ISSUE: Permit to Demolish/Capsulate (partial), Certificate of Appropriateness for addition and alterations

APPLICANT: Avonlea, LLC

LOCATION: Old and Historic Alexandria District
322 and 324 South Lee Street

STAFF RECOMMENDATION

Figure 1: BAR97-0260 plans for south elevation

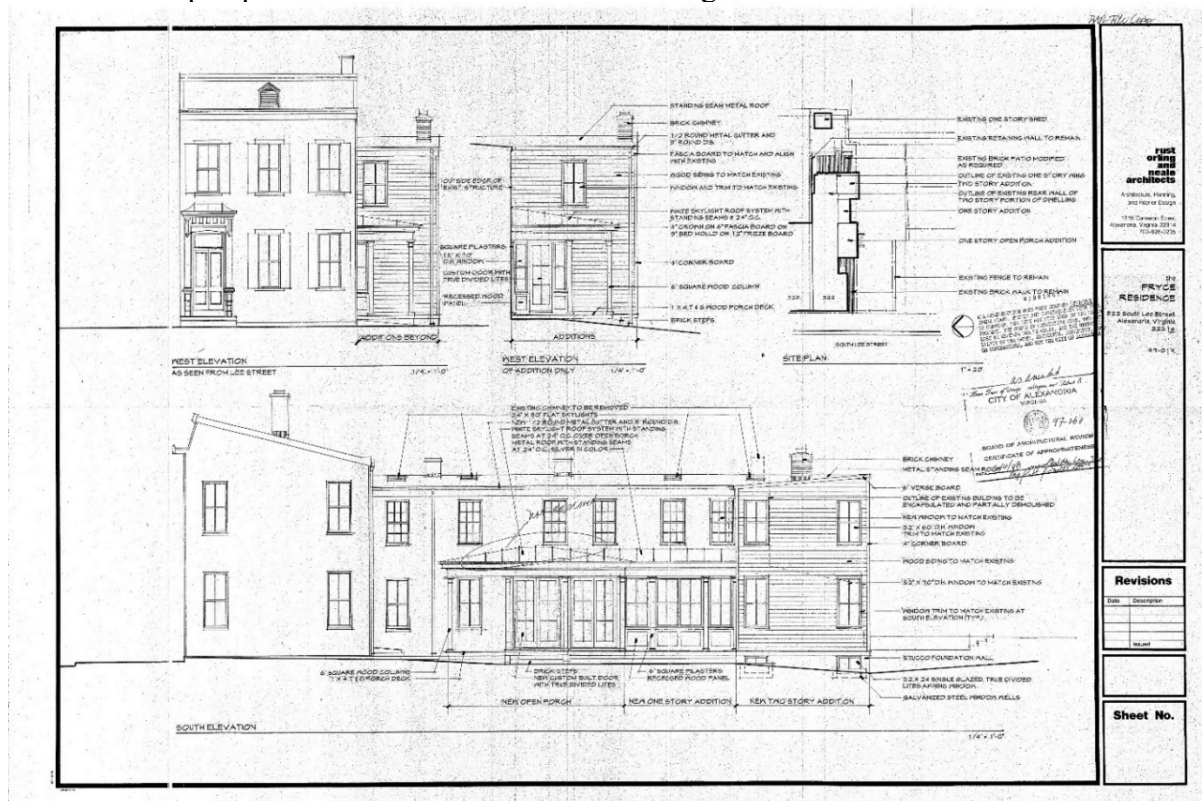
The above two cases approved the construction of the two-story addition at the rear/east end of the house and the open porch on the south elevation. See Figure 1.
